Re: Oconee Nuclear Station  
Docket Nos. 50-269, -270, -287

Pursuant to 10CFR50, §50.90, please find attached a proposed amendment to the Technical Specifications for the Oconee Nuclear Station, Appendix A to Facility Operating Licenses DPR-38, -47, and -55. This proposed amendment incorporates changes to the pressurization heatup and cooldown limitations for Oconee Unit 2. These changes are based on the attached report, "Analysis of Capsule OC11-C from Duke Power Company Oconee Unit 2 Reactor Vessel Materials Surveillance Program," BAW-1437, June, 1977.

### 3.1.2 Pressurization, Heatup, and Cooldown Limitations

UNIT 2  
 REACTOR COOLANT SYSTEM  
 NORMAL OPERATION HEATUP LIMITATIONS  
 APPLICABLE FOR FIRST 6.0 EFPY  
 OCONEE NUCLEAR STATION

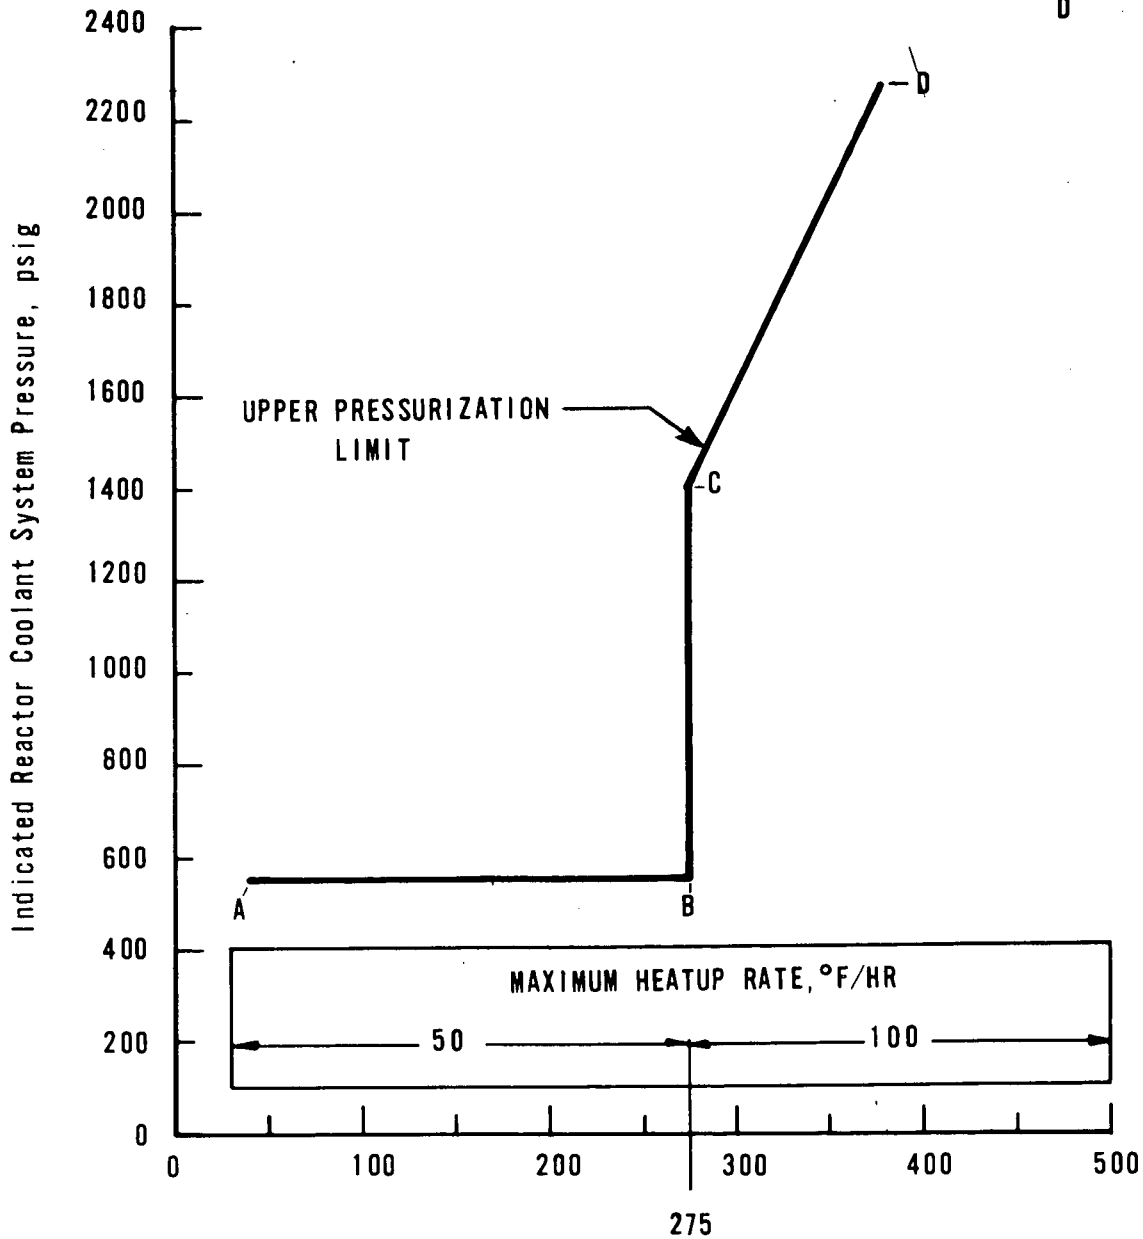
Replacement pages for the Oconee Nuclear Station Technical Specifications are attached. Proposed changes are identified by vertical lines in the margins.

POINT	TEMP.	PRESS.
A	40	550
B	275	550
C	275	1400
D	380	2275
